Monitoring Report MY01

**Sandy Bridge Restoration Site
DMS Contract 6400
DMS Project Number 96920**

Re: Response to Sandy Bridge Farm MY01 Report Comments

SITE ASSET MAP
SANDY BRIDGE FARM RESTORATION SITE
RUTHERFORD COUNTY, NC

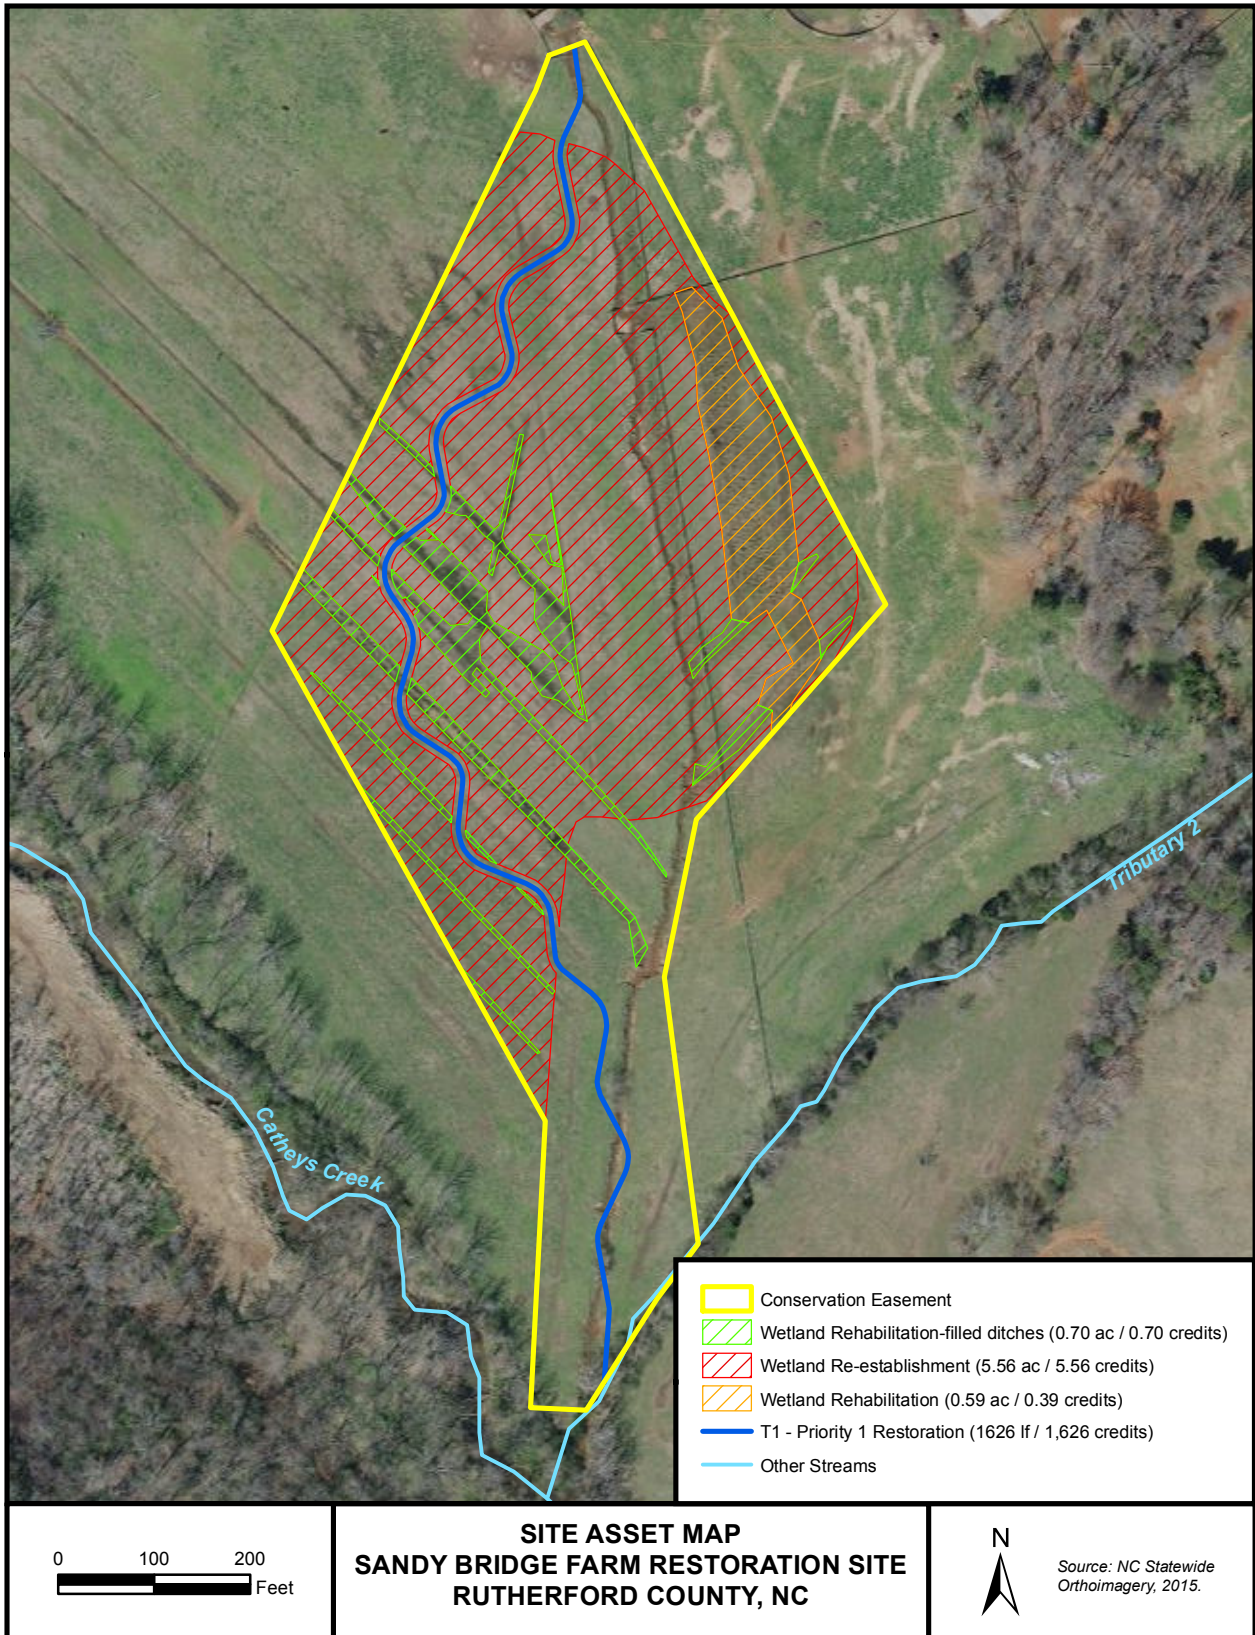
1. Aerial on Asset map is dated 2010 while CCPV shows 2015 aerial. Is it possible to update the asset map with the 2015 aerial?

KCI Response: This change has been made.

DATE: DEC 2017
SCALE: GRAPHIC
**CURRENT
CONDITION
PLAN VIEW**

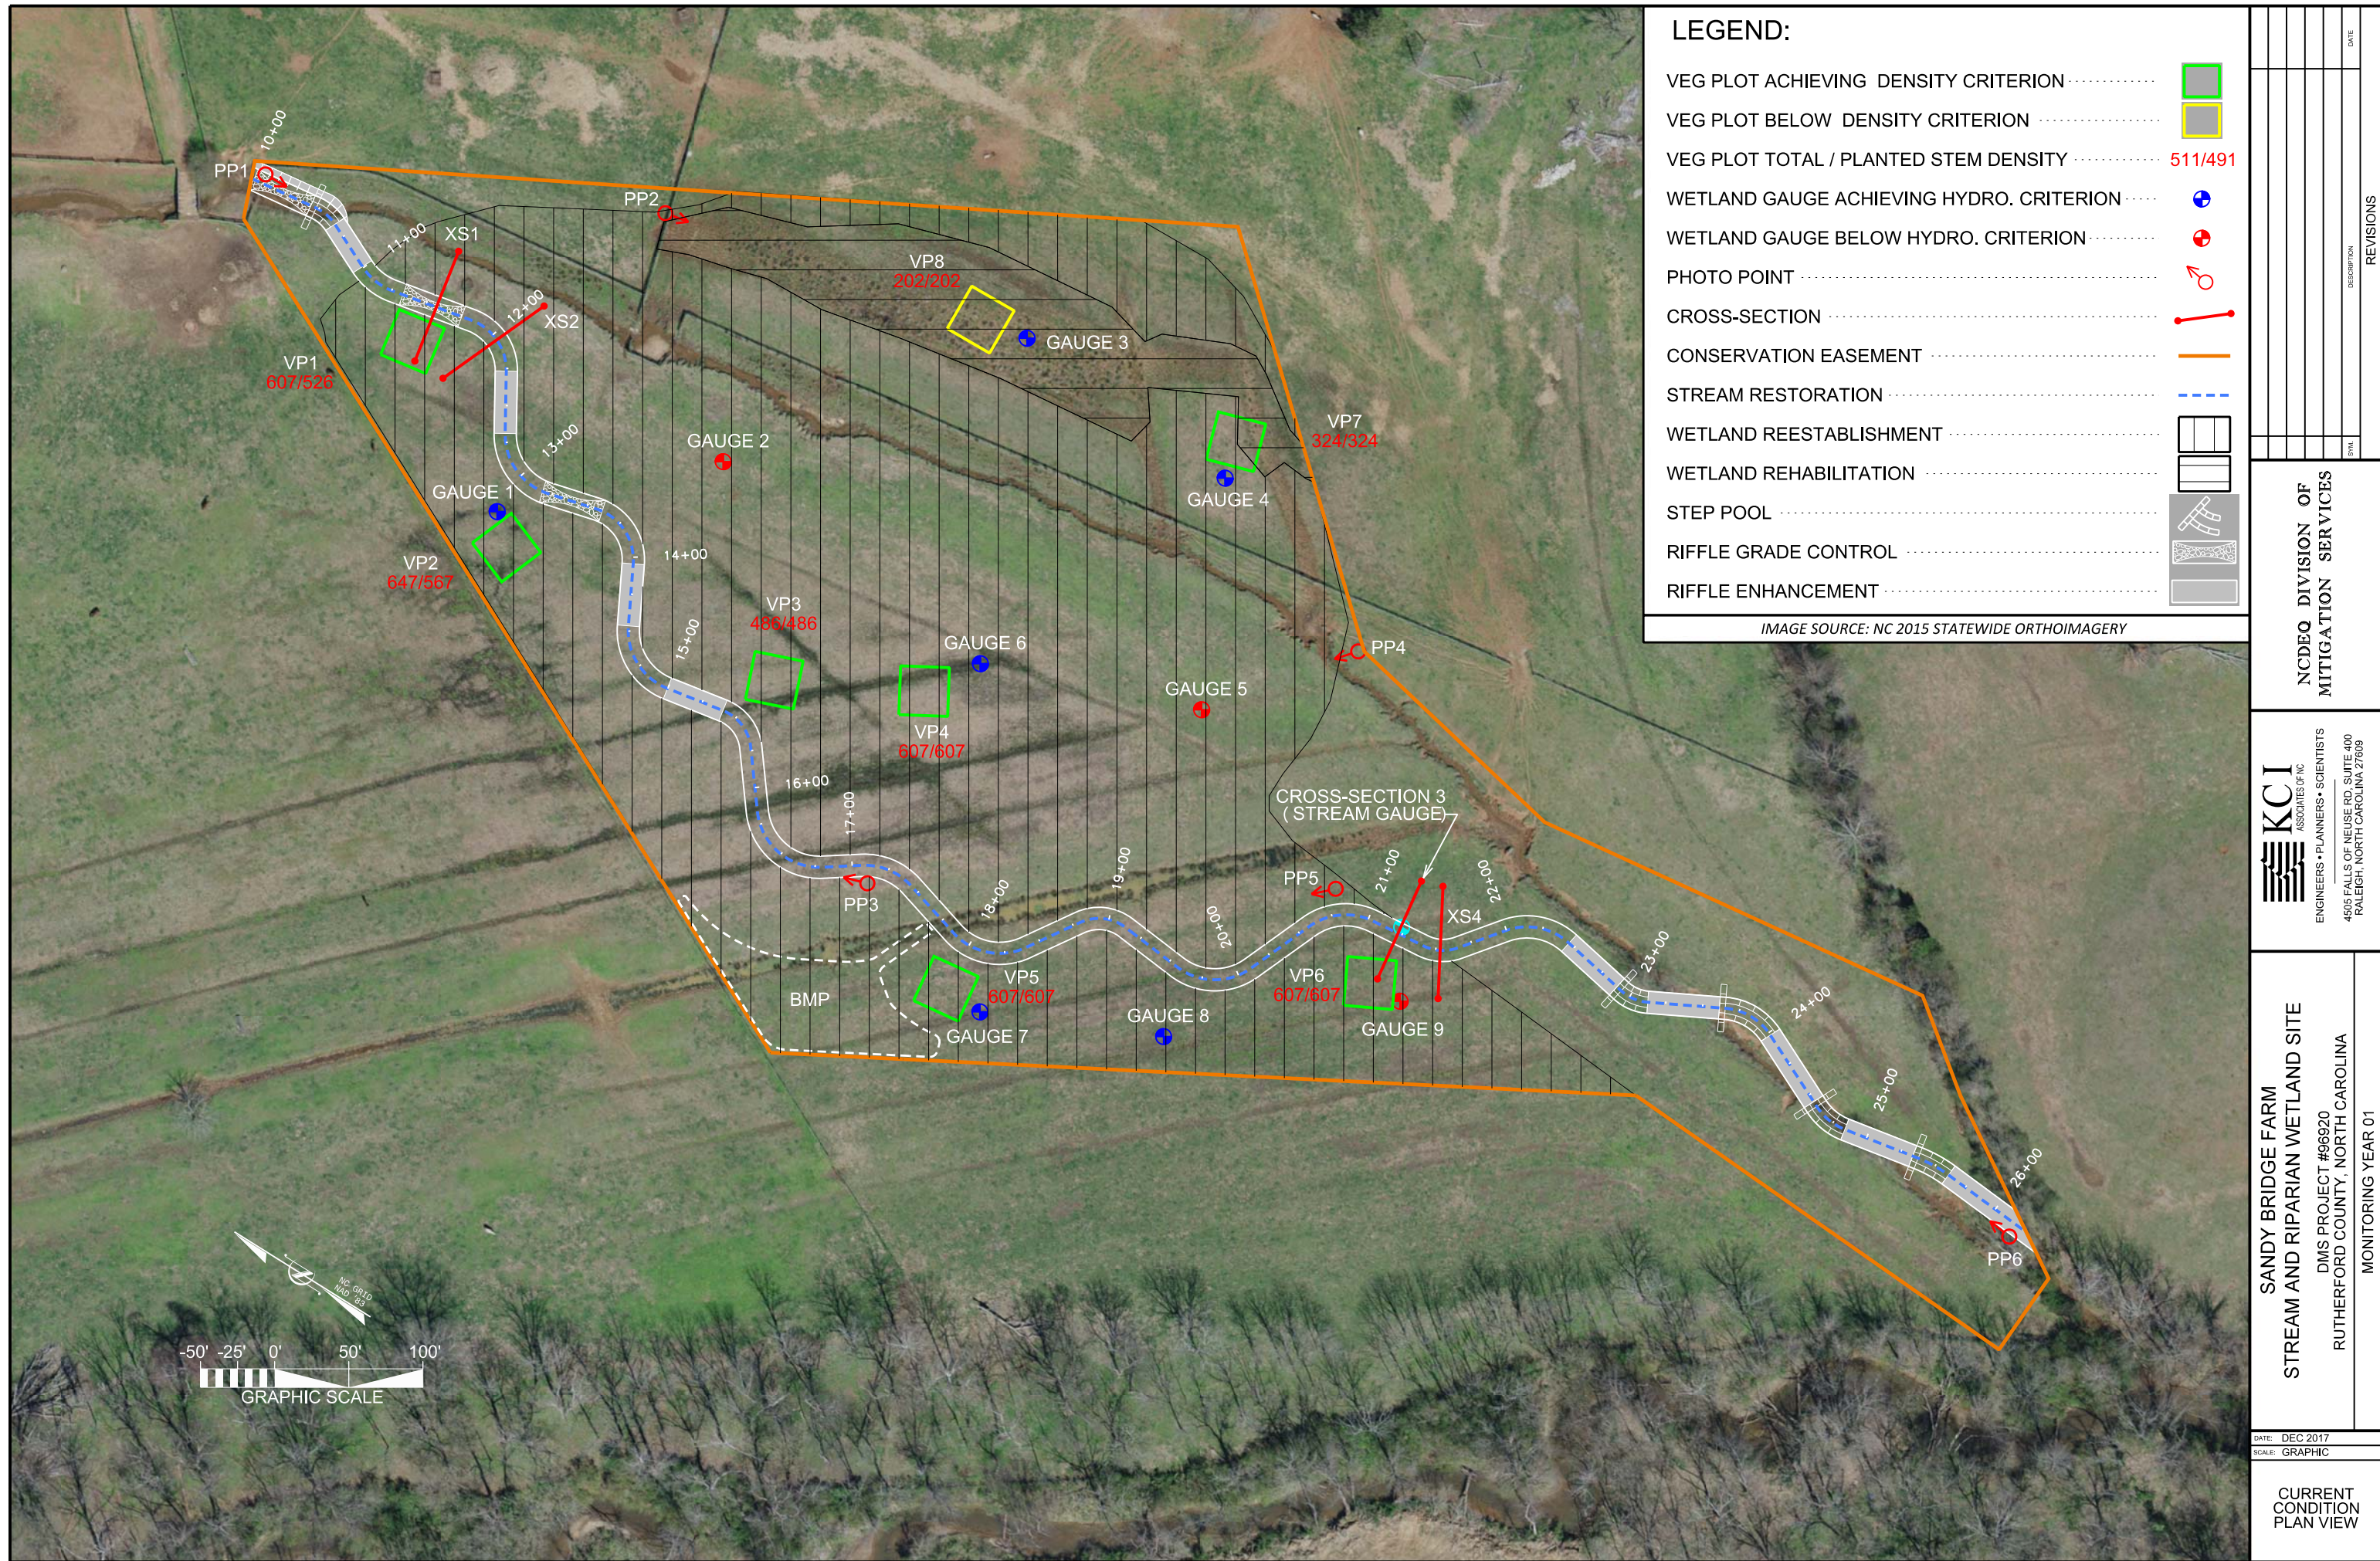
2. CCPV figure indicates “EDMS” project. Should this be “DMS”?

KCI Response: This typo has been corrected.
